## SERVICE INFORMATION NO. SI 40-086

GARMIN: Service Bulletin No. 0823 Rev. B  
ATA-Code: 34-00

**NO.: 0823 Rev B**

**SUBJECT:** GDU 104X CRS/BARO Knob Interference

**Figure 1**

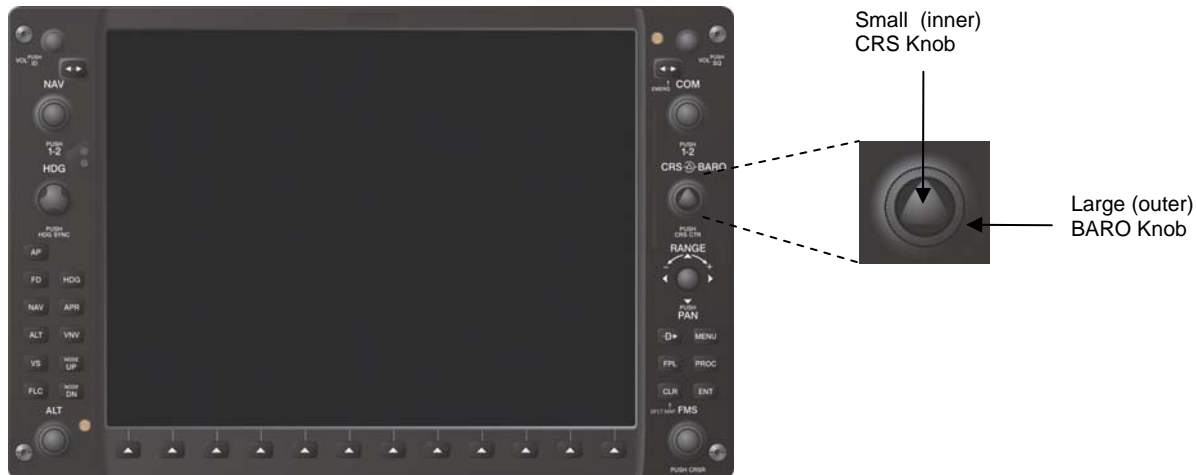
Garmin has identified an issue, whereby the large (outer) BARO knob and the small (inner) CRS knob may interfere with each other.

1. Apply power to the G1000/G900X/G950.
2. Press the CDI softkey on the Primary Flight Display(s) (PFD) to enter VOR mode on the HSI.
3. Rotate the large (outer) BARO knob (refer to Figure 1) a minimum of three complete revolutions in each direction while monitoring the Horizontal Situation Indicator/Digital Course Indicator (refer to Figure 3) on the PFD. If a change in the Horizontal Situation Indicator/Digital Course Indicator is produced while turning the BARO knob proceed to the Modification Instructions.

4. Rotate the small (inner) CRS knob (refer to Figure 1) a minimum of three complete revolutions in each direction while monitoring the Barometric Altimeter Setting (refer to Figure 3) on the PFD. If a change in the Barometric Altimeter Setting is produced while turning the CRS knob proceed to the Modification Instructions.
5. Repeat Steps 3 and 4 for each affected GDU.

If CRS/BARO Knob interference is confirmed, perform the steps below to replace the CRS/BARO Knob. New knobs can be obtained through a Garmin Service Center or Aircraft OEM under Garmin part number K00-00446-00.

1. Grasp the small (inner) CRS knob and firmly pull the knob off the shaft.
2. Discard knob.
3. Grasp the large (outer) BARO knob and firmly pull the knob off the shaft.
4. Discard knob.

**Figure 4**

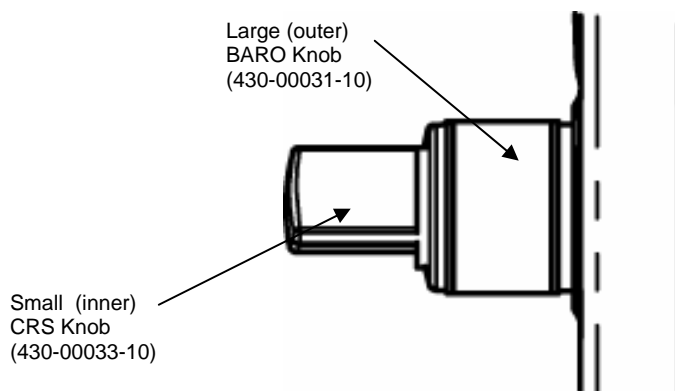
5. Grasp the large (outer) BARO knob (insuring proper orientation) and place it over the shaft.
6. Align the flat side of the knob insert with the flat side of the shaft.
7. Press down firmly to ensure knob is completely seated, refer to Figure 4.
8. Grasp the small (inner) CRS knob (insuring proper orientation) and place it over the shaft.
9. Align the flat side of the knob insert with the flat side of the shaft.
10. Press down firmly to ensure knob is completely seated, refer to Figure 4.
11. Perform the CRS/BARO Knob Interference Test (contained in the TESTING PROCEDURE section) again to confirm there is no interference.
12. Accomplish aircraft logbook entry to return aircraft to service in compliance with this service bulletin.
